International Code Council

**ICC 300-2020 edition
Public Input Agenda
based on input received
on 2017 edition of the
ICC 300 Standard**

**Draft for January, 2022
Revised 2/2/2022
Meeting – Teleconference**

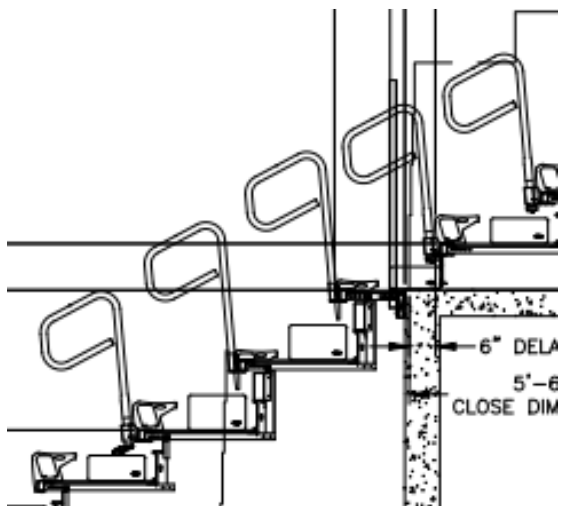
On Folding and Telescopic Seating, handrails that span multiple tiers prevent the operation of the bleacher with the handrail in place. Several tiers may be involved resulting in large heavy rails that require removal every time the bleacher is operated. The image below shows such a rail that would weigh in the vicinity of 35 lbs. Once removed, there is no guarantee that the attachments used to hold the rail to the bleacher will return to the exact location making reinstallation extremely difficult (if not impossible).

By putting the rails and attachments on individual tiers, the rail are lighter and the attachments are not required to repeatedly line up with other moving tiers.

406.8.1 Tread and riser nonuniformity permitted. Treads and risers located in transition areas between adjacent tiered seating elements, parabolic seating configurations or onto or off of tiered seating are not required to be of uniform depth or height where a ~~mid-aisle~~ aisle handrail is provided. The handrail shall meet the requirements of Section 409. ~~Mid-aisle~~ Aisle handrails in transition areas shall extend the full length of the transition and a minimum of one tread depth, parallel to the run of the stepped aisles, above and below the uppermost and lowermost riser in the transition. Where extensions of the aisle handrail interfere with adjacent means of egress, the handrail extension shall terminate at the riser.

Exception: On folding and telescopic seating the handrail at transitions shall be permitted to be discontinuous in accordance with Section 409.1.1.

CROSS BAR IS LOCATED TO STOP
PASSAGE OF A 4 INCH SPHERE
WHEN THE 34 INCH IS MEASURED
TO THE TOP OF THE SPHERE.

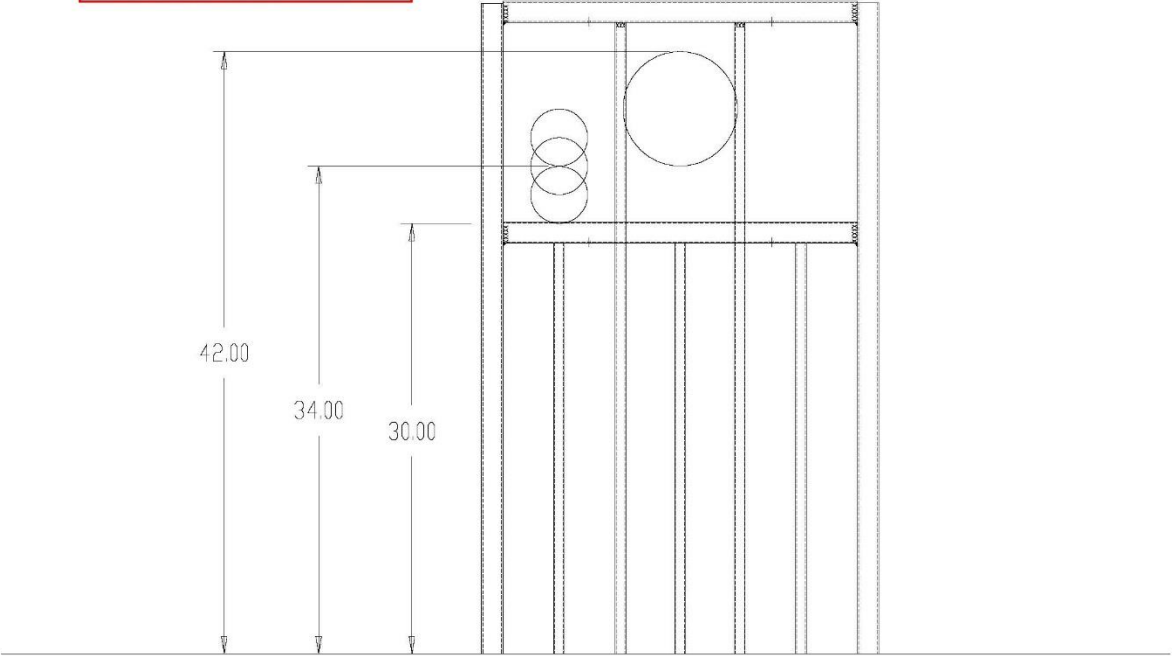
Reason: This proposal assumes that my proposal for revision to section 408.1 is approved. The lower reference is clarified from “the adjacent walking surface” to the enumerated references of the revised 408.1. Adding “to the bottom of the sphere” locates the height of the sphere. Per figure 1 which follows, the cross bar could interpreted to be as low as 30 inches. By adding “to the bottom of the sphere”, the minimum cross bar height is clarified to be 34 inches. I believe that was the original intent.

The 42 inch height in the original requirement has no meaning. Rail heights are allowed to exceed that height and often do as shown in figure 1. I believe the intent is to stop the 8 inch sphere as high up as the rail goes.

408.2 Opening limitations. Open guards shall be constructed of materials such that a 4-inch-diameter (120 mm) sphere, cannot pass through any opening up to a height of 34 inches (864 mm) measured vertically in accordance with Section 408.1 to the bottom of the sphere. ~~From Above~~ a height of 34 inches (864 mm) ~~to 42 inches (1067 mm)~~ above the adjacent walking surfaces, a sphere 8 inches (203 mm) in diameter sphere shall not pass.

AS INTERPRETED TO
BOTTOM OF SPHERE

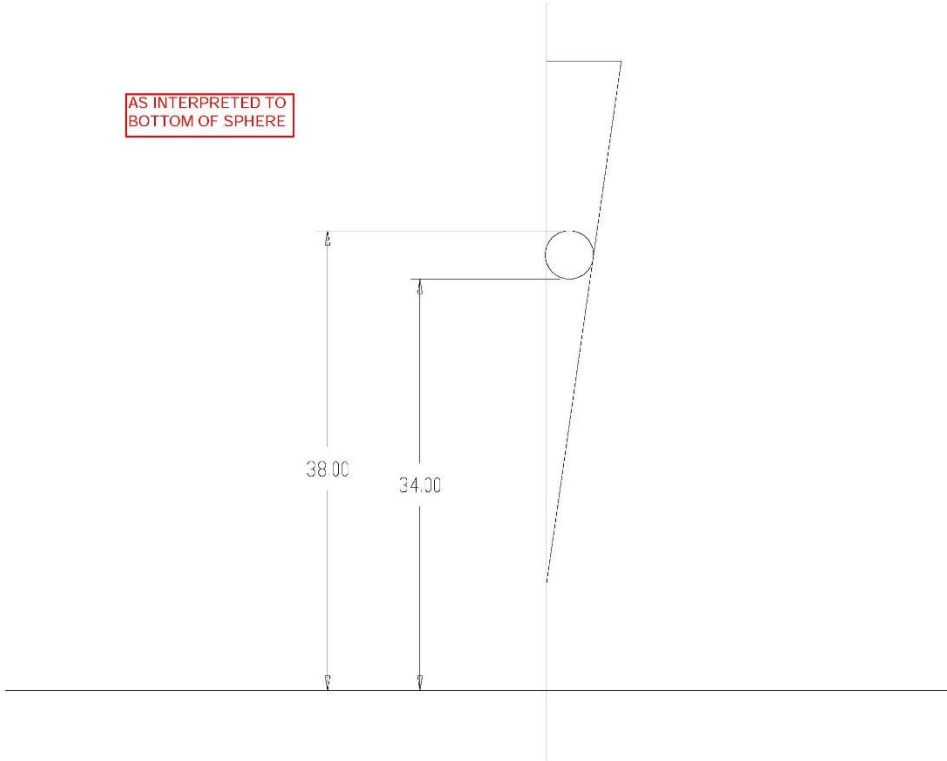
Figure 2 which follows shows a situation somewhat common in telescopic seating because the guards slope away from the seating for the purpose of making them nest in storage or retraction. If the height of the sphere is not defined, one may not be able to accurately say if an opening is compliant or not.

Figure 6 First United Methodist Church in Kalamazoo, MI
 Handrail built into end of pew. Stepped aisle with seating on one side.
 The knob dimensions sited are common for door knobs.

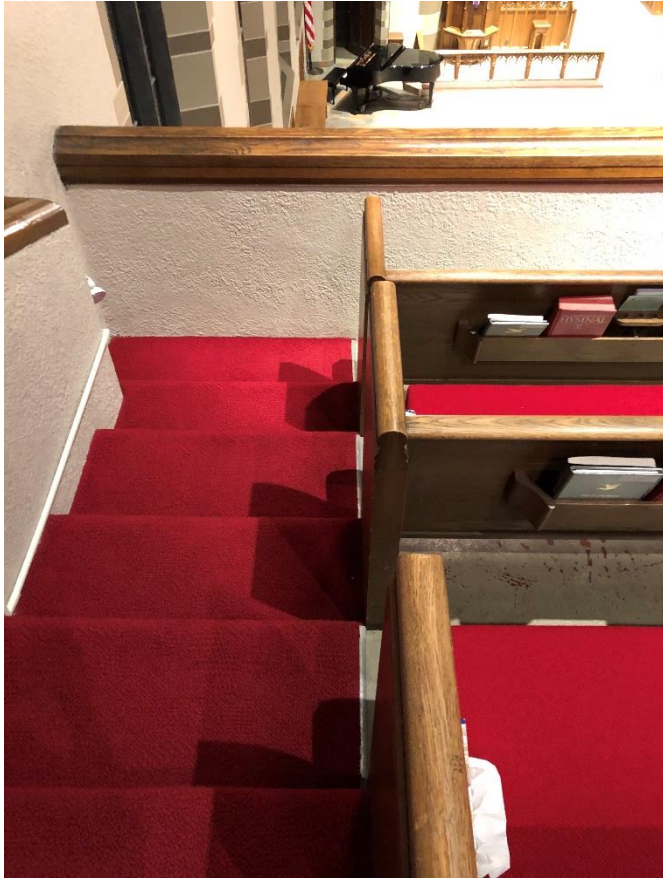
A new section has been added for handrails adjacent to seats. For examples, see figures 2 through 6. Handrail systems adjacent to seats are more commonly used in steeper seating found in balconies and upper tiers where providing fall arrest is critical. Use of a knob as an individual handrail is proposed. An example is shown in figure 4. The doorknob industry standard dimension information is provided in figure 6.

Exception: A 1-7/8 inch (47.6 mm) to 2-7/16 inch (61.9 mm) diameter knob shall be permitted as a handrail adjacent to seats and shall be considered rounded and graspable.

Figure 9

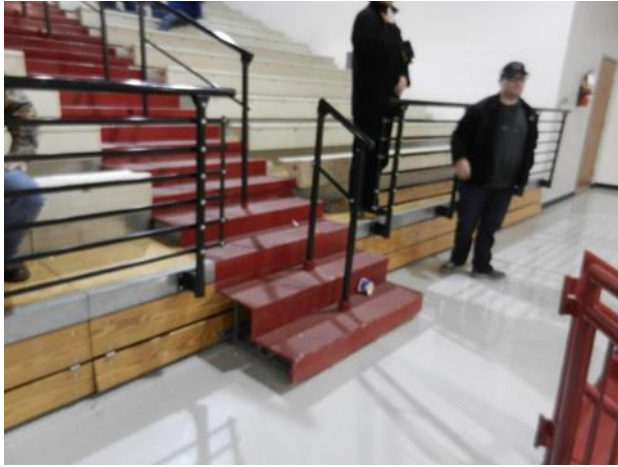
A handrail placed at the sides of a stepped aisle is effective when placed at the transition onto or off of tiered seating. This type of rail is shown on the back cover of ICC 300-2017 and Figures 8 and 10. The new text also provides for a single mid-aisle rail as shown in figure 9. On narrower aisles, where seating above is on only one side and the aisle width is allowed to be less than 48 inches (as low as 36 inches). On these narrow aisles extensions where there seating on neither side, an allowance is made to provide a continuous handrail on one side only. Being so narrow it is not likely people will be egressing down both sides of the aisle.

1. A single mid-aisle handrail shall be permitted in lieu of the two continuous handrails where the stepped aisle is a minimum of 48 inches (1219 mm) wide.
2. A continuous handrail is permitted to be on only one side of the stepped aisle where the stepped aisle is less than 48 inches (1219 mm) wide.

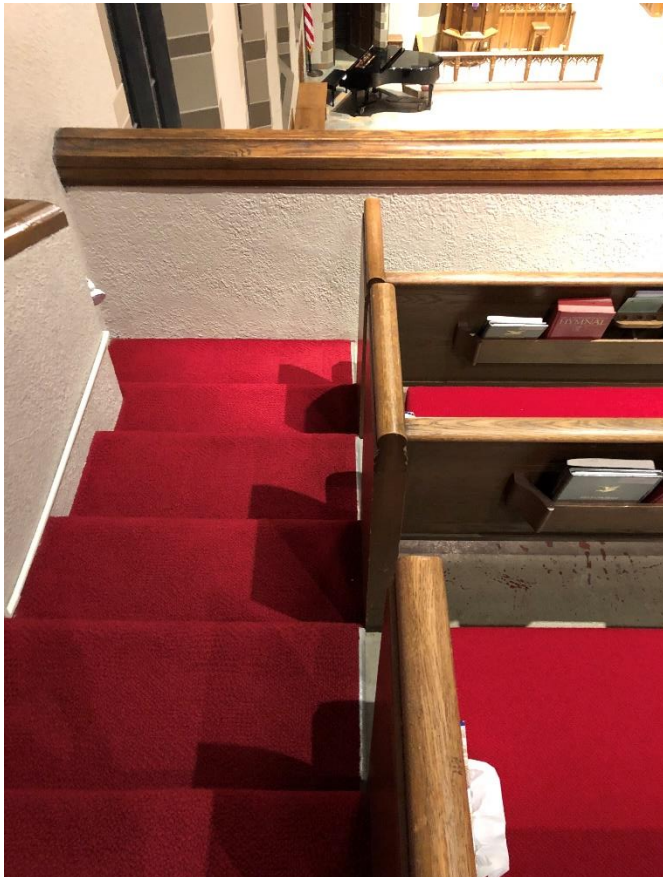
Reason: This proposal picks up the handrail graspability options in IBC Section 1014.3. This is based on recent studies sponsored by the Stairway Manufacturers Association.

Exception: Where the handrail is the end cap of pew type seating, handrails shall be in accordance with Section 409.3.1, 409.3.2 or shall provide equivalent graspability.

409.3.1 Type I. Handrails with a circular cross section shall have an outside diameter of at least 1.25 inches (32 mm) and not greater than 2 inches (51 mm) or shall provide equivalent graspability. If the handrail is not circular, it shall have a perimeter dimension of at least 4 inches (102 mm) and not greater than 6.25 inches (159 mm) with a maximum crosssection dimension of 2.25 inches (57 mm). Edges shall have a minimum radius of 0.01 inch (3.2 mm).
